**Appendix I:**

**Comments Received on the DEIS**

## **LIST OF GROUPS AND INDIVIDUALS WHO COMMENTED ON THE DEIS**

Map 7: Areas within One Hour of Jamaica via Long Island Rail Road or 45 Minutes via Subway (with ES Access)

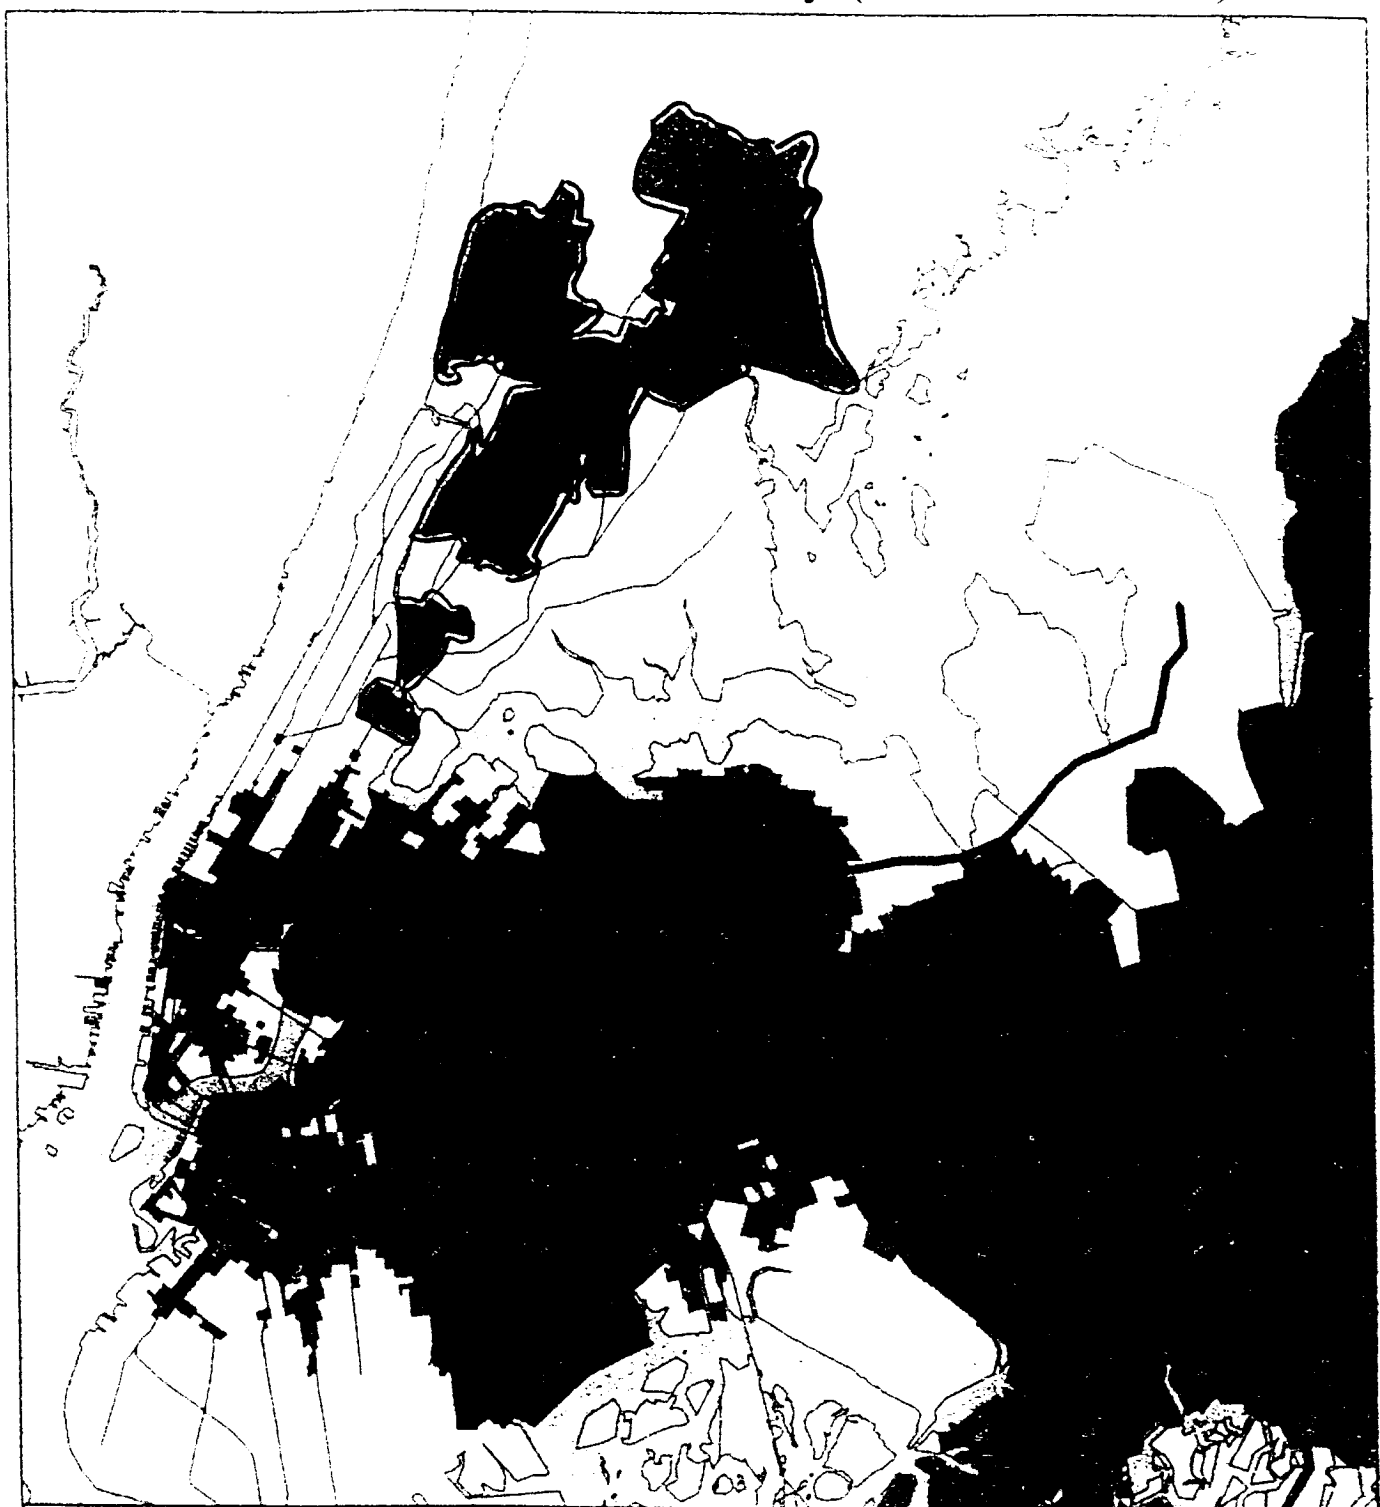
The attached map indicates the geographic areas of the region which ESA will bring within a 45 minute ride from Jamaica Center which is now significantly expanded to the north by the anticipated connection with Grand Central. We estimate that 345 thousand workers from the northern suburbs and upper Manhattan would be added to our Jamaica labor shed; 51 thousand from Manhattan, and 204 thousand from the Bronx, and 71,000 from Westchester.

## **PLATFORM LENGTH**

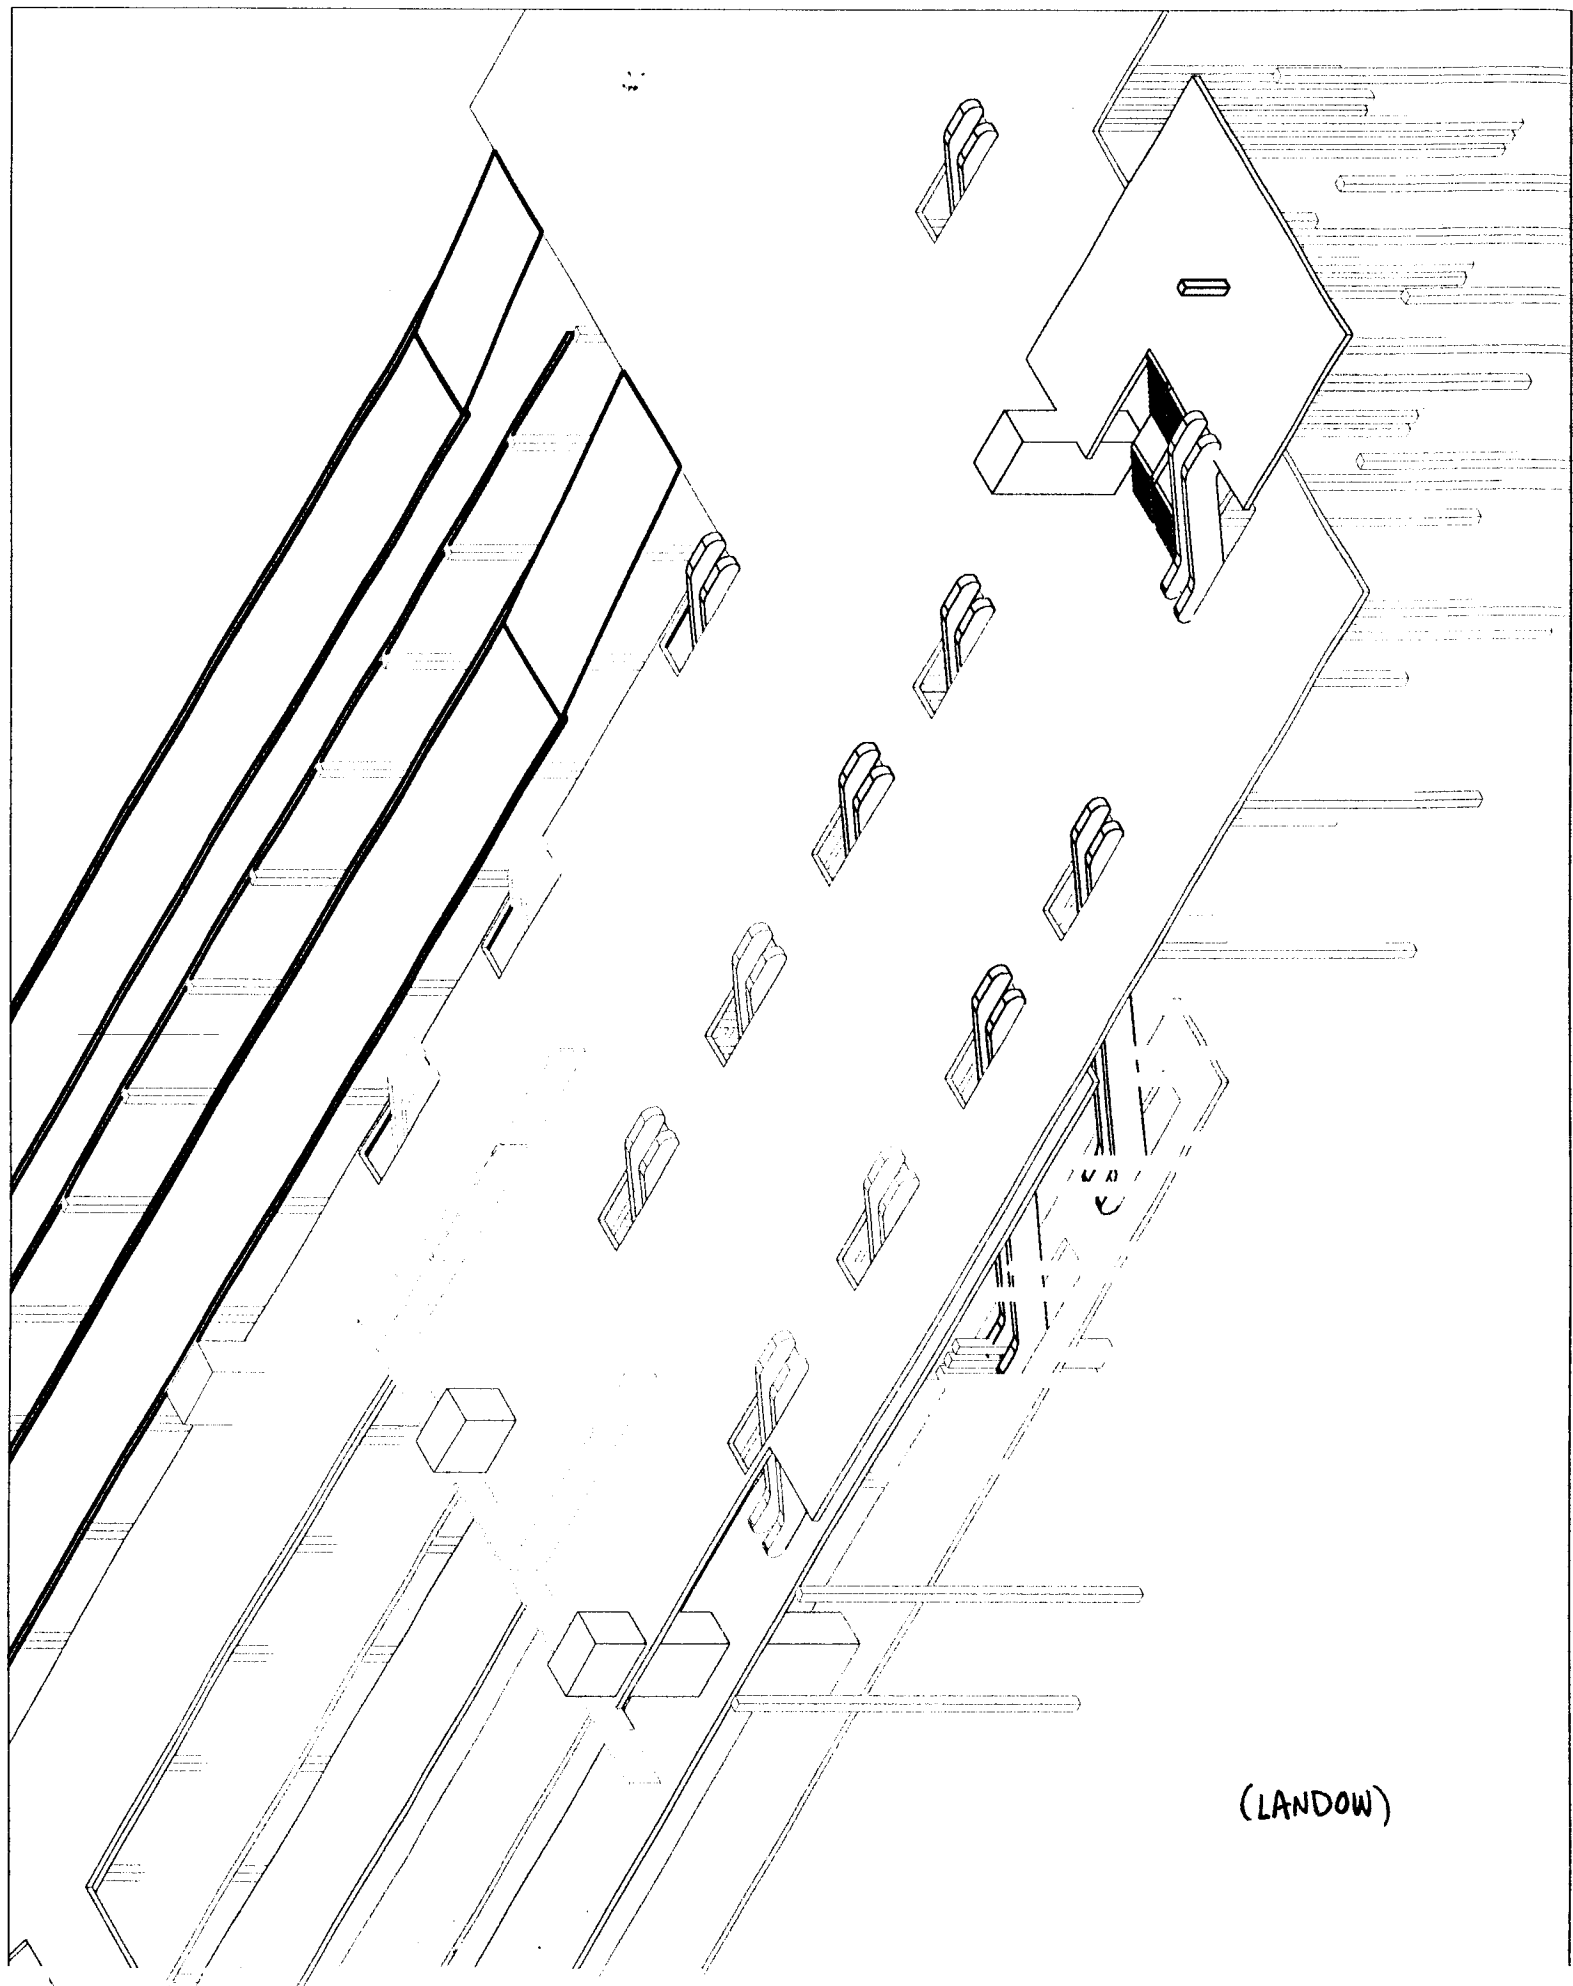
If both the MNRR and LIRR are connected as described, the south end of the platforms can be shifted from N 5+60 south to N 4+00. This 160 feet is just short of two car lengths. The exact platform length varies with the curve location. This lengthens length for MNRR and retains the proposed length for the LIRR.

## ARRIVAL STATION – EXPANSION OF AREA

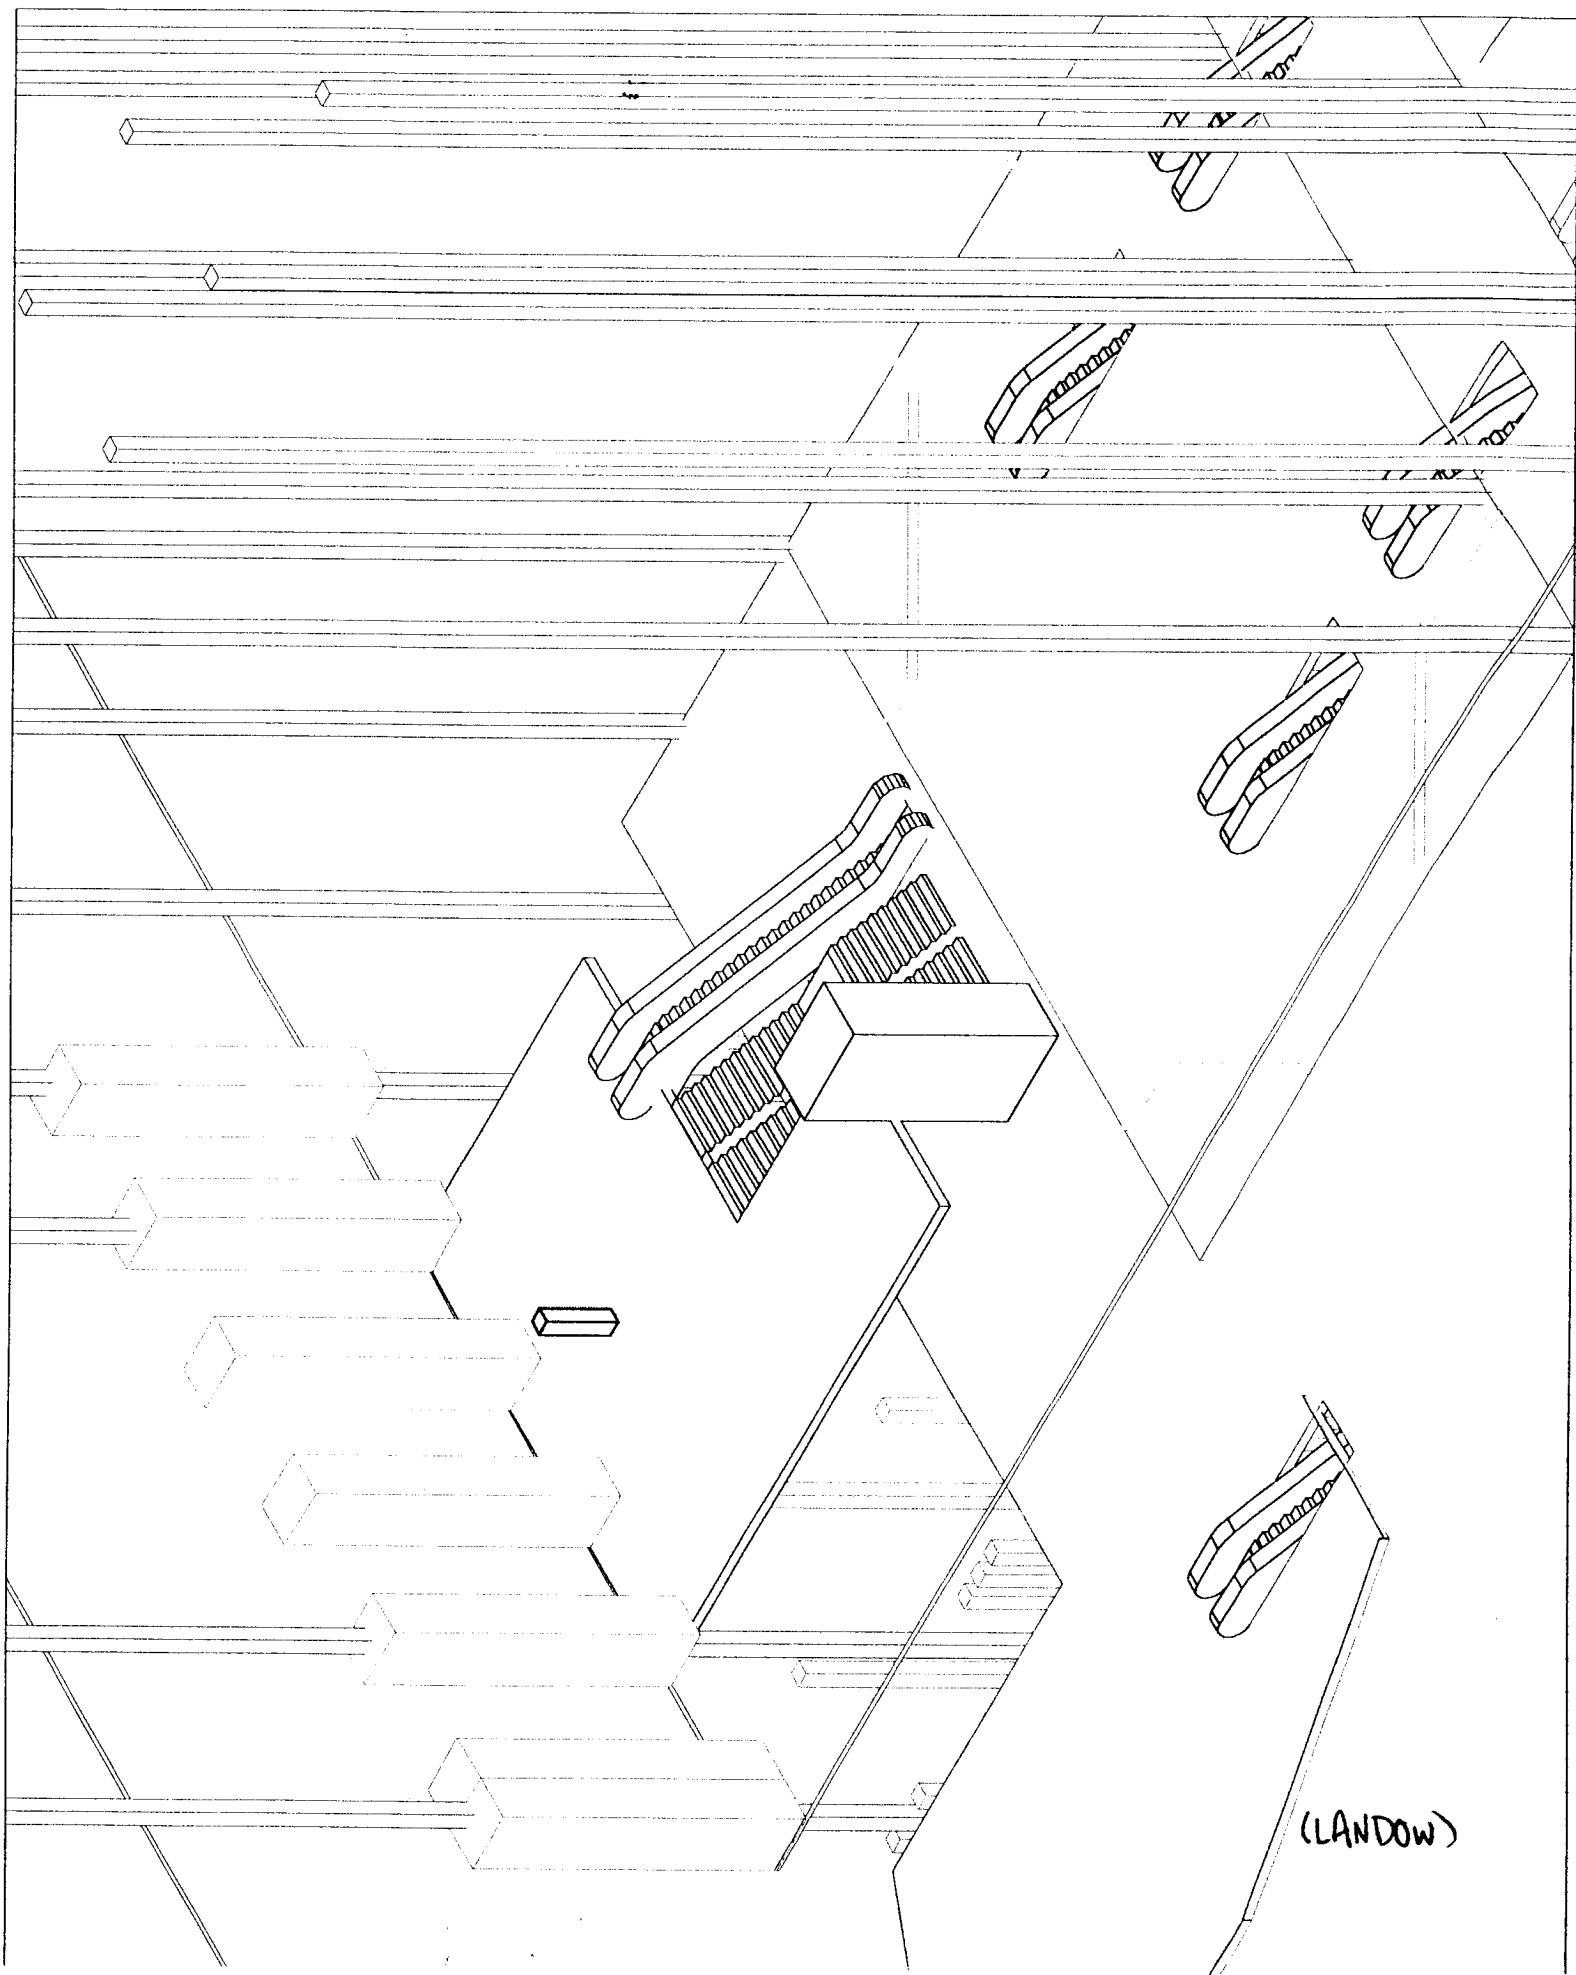
We propose to expand the surface area of this region by 90%. This will increase the waiting and commercial areas significantly. The existing area is 7544 sqft. The new area adds 6800 sqft.

The expansion includes 3 of the 4 **offices** (green shading). The westernmost office is not used in the expansion. The office spaces are located between N 4+18 and N 4+70. On the East axis, they extend from E 2+22 to E 2+90. They are separated by the ramps for tracks 41-42 and 39-40. The gross office area taken is approximately 68 x 52, 3536 sqft.

The expansion also includes a **new floor** north of the existing offices (in gray shading). The office floor already extends 10 ft under 44<sup>th</sup> street north of the building line. The additional 50' (60-10) is bordered by a major girder for the Yale Building. Another major brace running north/south is used in the north 40 feet of the street. This limits but does not totally block pedestrian circulation. We propose to extend the floor north to N 5+18, near the north edge of 44<sup>th</sup>. This will expand the floor by 68 x 48 ft, 3264 square ft.

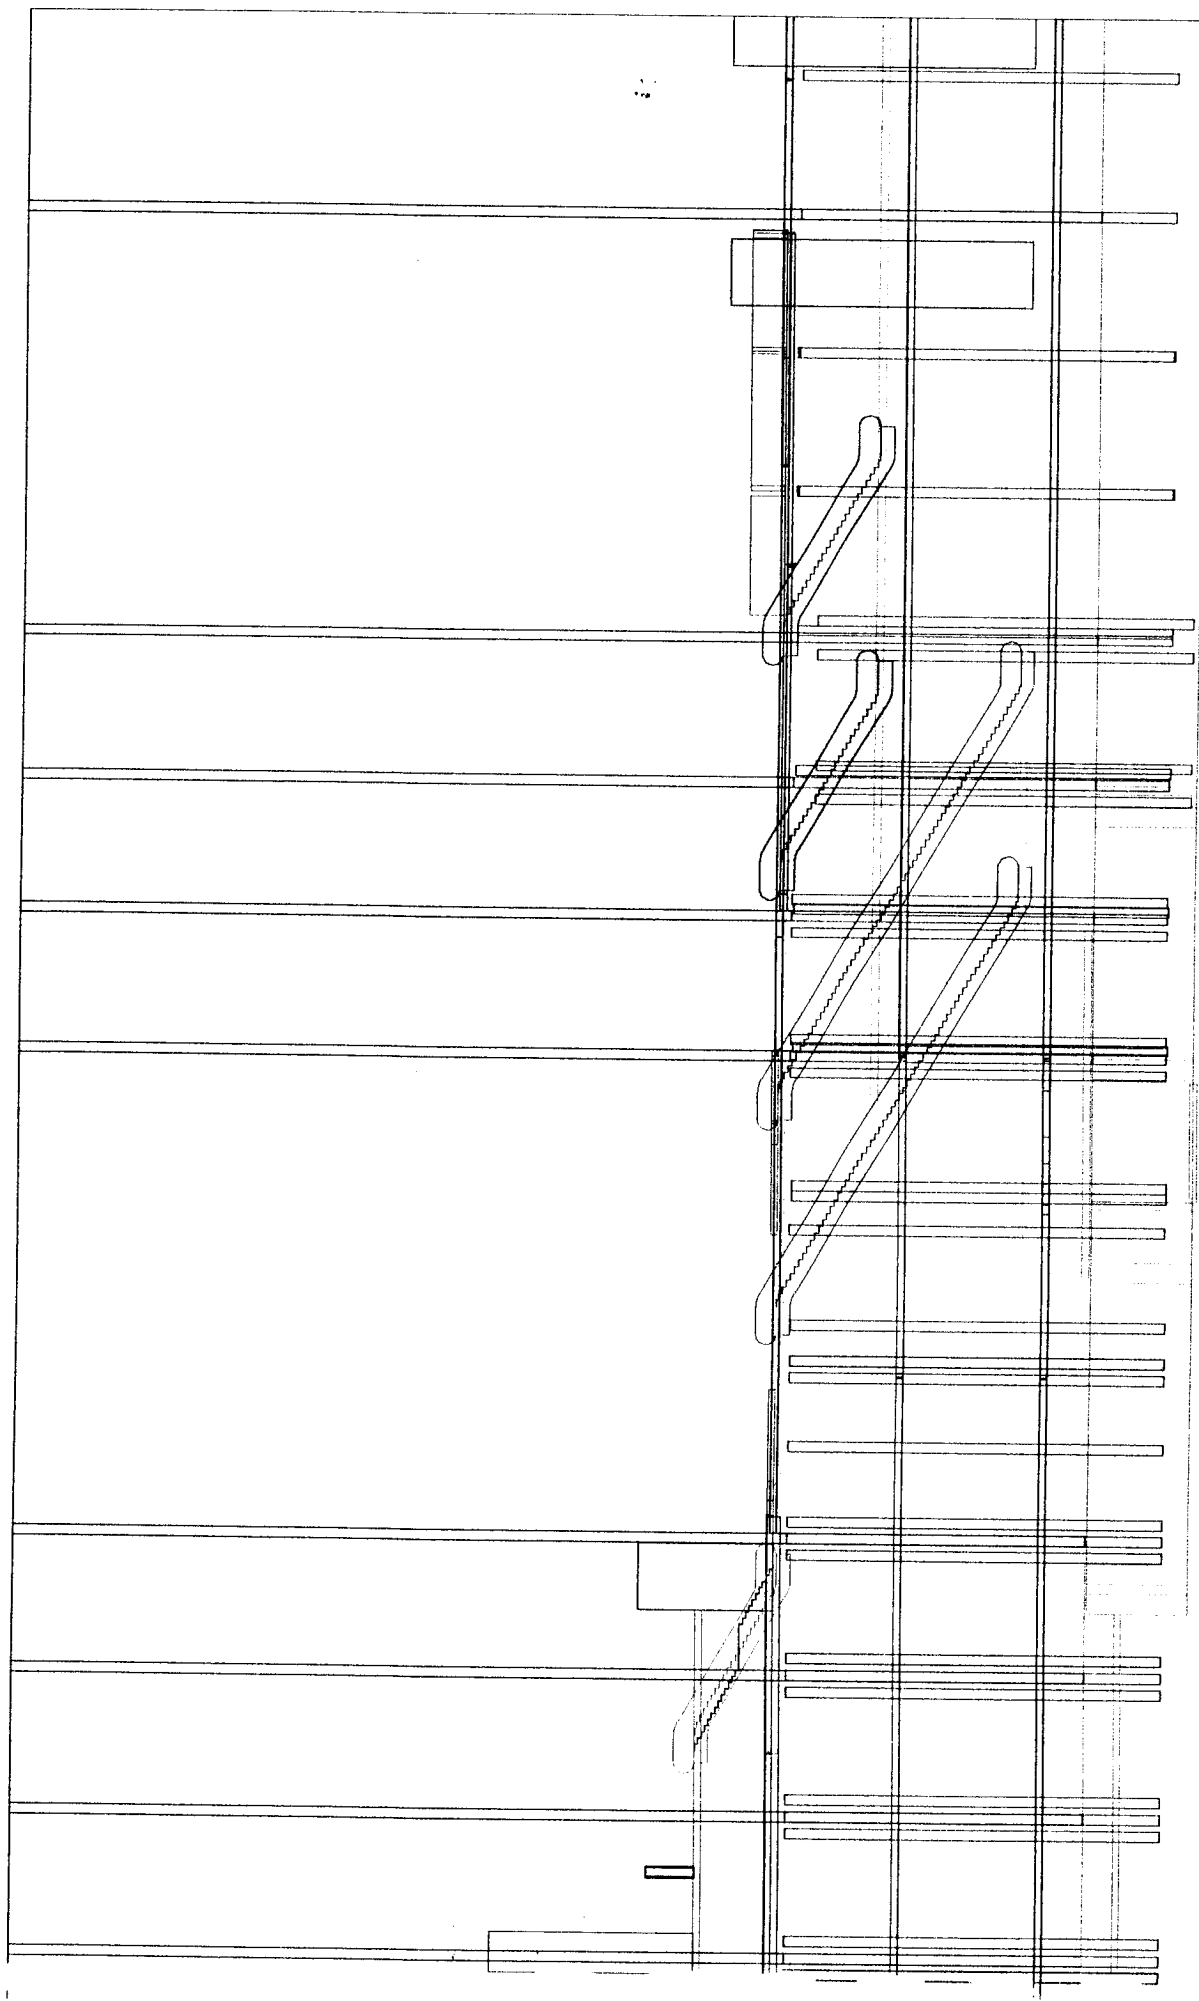
A three foot wide door satisfies current ADA standards. A four-leaf door will allow the 3 feet to be folded into 9" areas to each side of the door. Having two doors on opposite ends of the elevator would allow usage from/to either direction without requiring the user to move around the elevator to reach the door.

Three elevators are used in situations where little or no headroom exists above the arrival station level. This requires that the motor room be placed below the unit, under the lower level platform.

Only three platform elevators are required in the proposal. This is the same as the STV proposal for the same platforms. However, this new proposal serves the upper level tracks 38-42 as well, avoiding the use of the long ramp by ADA passengers.
